# HISTORIC AND DESIGN REVIEW COMMISSION

August 16, 2017

**HDRC CASE NO:** 2017-409  
**ADDRESS:** 512 N OLIVE ST  
**LEGAL DESCRIPTION:** NCB 571 BLK 5 LOT N 56 FT OF 9 & 10  
**ZONING:** RM-4 H  
**CITY COUNCIL DIST.:** 2  
**DISTRICT:** Dignowity Hill Historic District  
**APPLICANT:** Elida Cervantes-Gros  
**OWNER:** Guy Gros  
**TYPE OF WORK:** Porch modifications, window screen replacement  
**REQUEST:**

# Front Porch

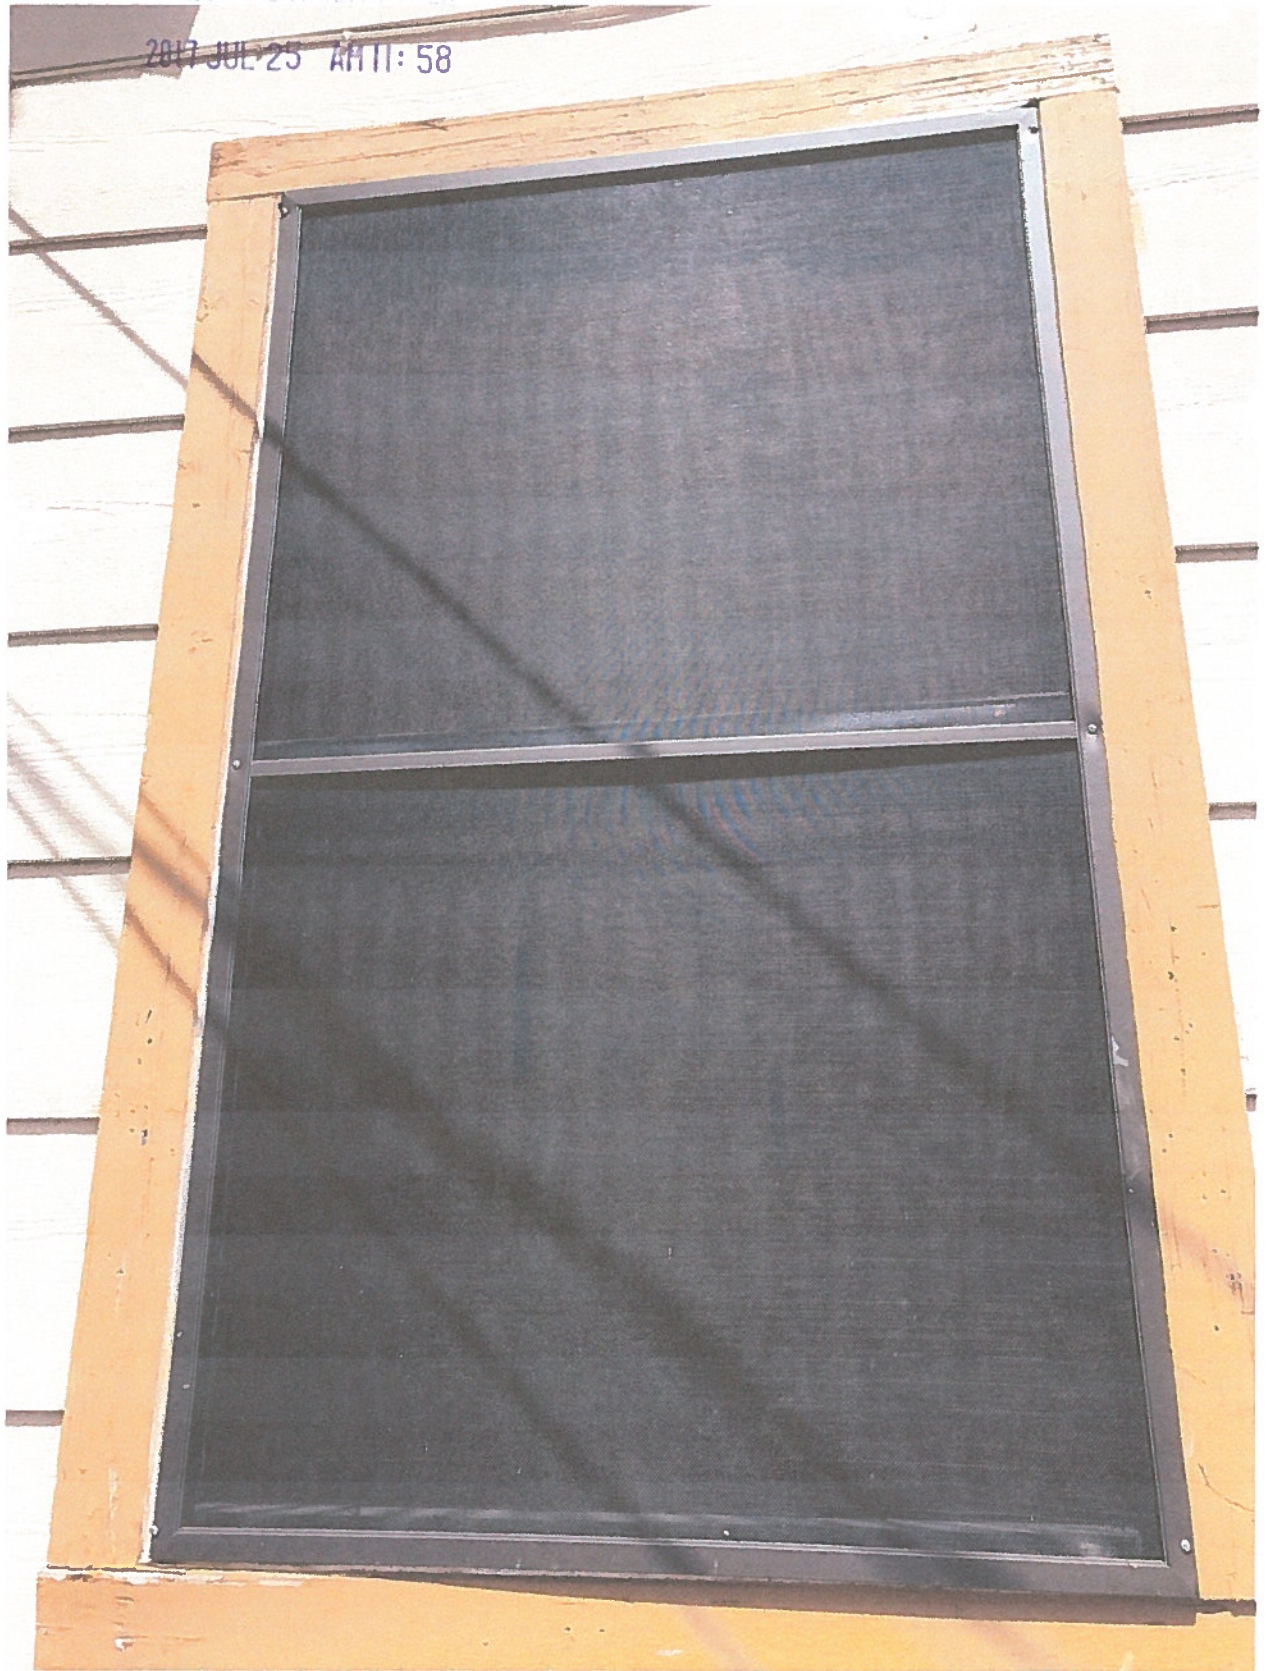
- b. PORCH MODIFICATIONS – The applicant has proposed to modify the existing porch railings and balustrades. The proposed railing will measure 40 inches in height to match the approximate height of the existing railing. The balustrades will be spaced 3 ½” apart and the top railing will measure 2x6” with a profile as indicated in the submitted photographs. The existing railing is in disrepair and does not appear to be original to the structure. According to the Historic Design Guidelines for Maintenance and Alterations, existing balusters should be preserved. Any new elements that are introduced should not detract from the historic material or be incongruent with the style of the historic structure. The proposed railing is compatible with the architectural style of the building. Staff finds the proposal consistent with the Guidelines with the stipulations listed in the recommendation.

Item 1, Staff recommends approval of the railing height modification based on finding b with the stipulation that the applicant submits final drawings that indicate the dimensions of the balustrades and a section profile of the final railing detail to be installed to staff for final approval.
